FUEL INJECTION PUMP TIGHTENING TORQUE SERVICE MANUAL REVISION

One of the tightening torques in the 'Fuel Injection Pump Tightening Torques' service manual (Publication No. EE10E-11012) has been revised.

Page 46 (12 COMPENSATORS' section)

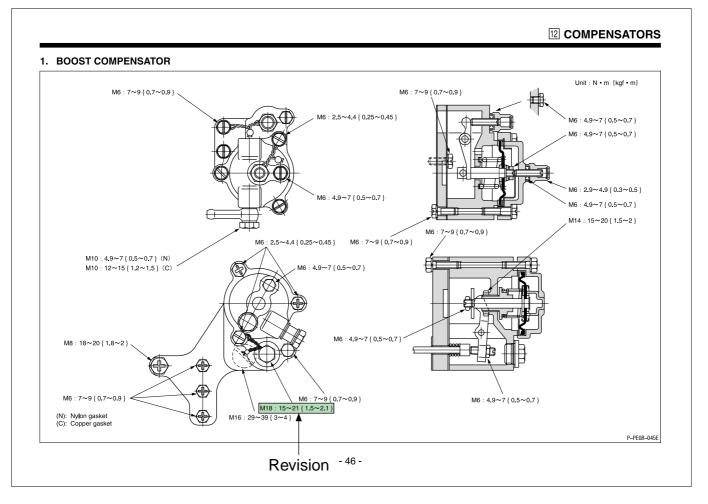
It was found that there was a difference between the torque specified by the Design Department and that implemented by the Manufacturing Department.

As a result of verification by the Design Department, the torque value was revised to that implemented by the Manufacturing Department.

- Location of revised torque value: Refer to 'Revision' in the figure below.
- New torque value: 15 ~ 21 {1.5 ~ 2.1} (Previous: 29 ~ 39 {3 ~ 4})
